**BSR/ASHRAE Addendum t
to ANSI/ASHRAE Standard 15-2024**

Proposed Addendum t to Standard 15-2024, Safety Standard for Refrigeration Systems

**First Public Review (February 2026)
(Draft shows Proposed Independent Substantive
Changes to Previous Public Review Draft)**

Figure 7-1 Refrigerant charge limit compliance path—Part 1.

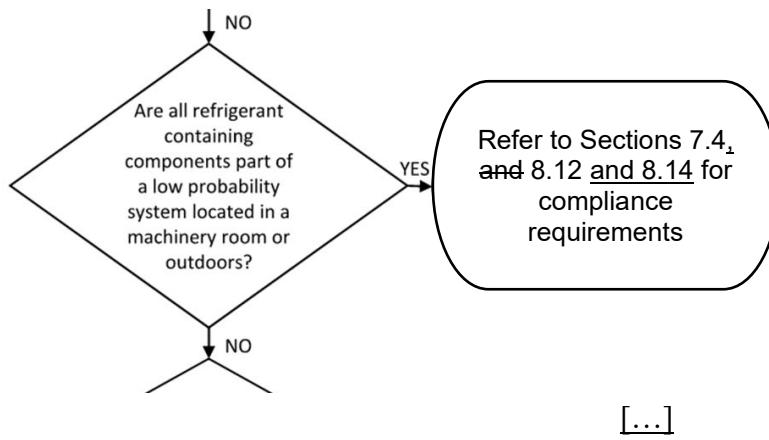
Modify the figure as follows, no other changes are made to the figure.
